**International Aero Engines  
NON-MODIFICATION  
SERVICE BULLETIN**

**ENGINE – ANGLE GEARBOX ASSEMBLY – TO ANNOUNCE A NEW GEARBOX WITH PARTIAL  
HEAT TREATED BEARING SUPPORT – NON-MODIFICATION SERVICE BULLETIN**

This document transmits Revision 1 of Non-Modification Service Bulletin V2500-ENG-72-0527

**V2500-ENG-72-0527**

Affected engines  
Figure 1

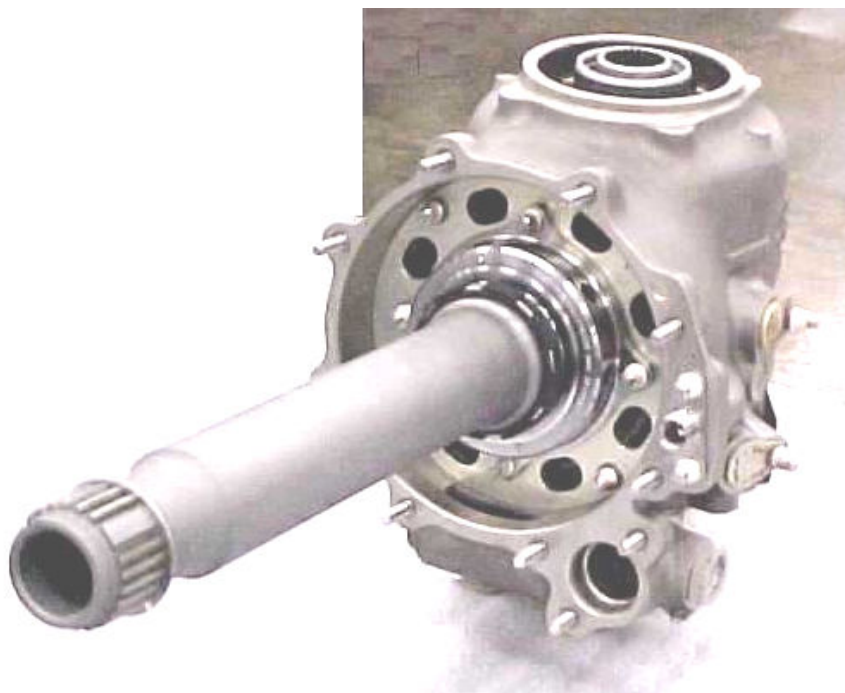
Remove	Incorporate	Reason for change
Pages 1 to 8 of the Initial Issue of Service Bulletin	Pages 1 to 8 of the Revision 1 of Service Bulletin	To correct table of affected engines.

- (1) Identify the affected engine. Before you start the work, make sure that the serial numbers of Engine, Gearbox Module, Main Gearbox and Angle Gearbox match according to the table of Fig.1. Report any discrepancy to International Aero Engines Technical Services.
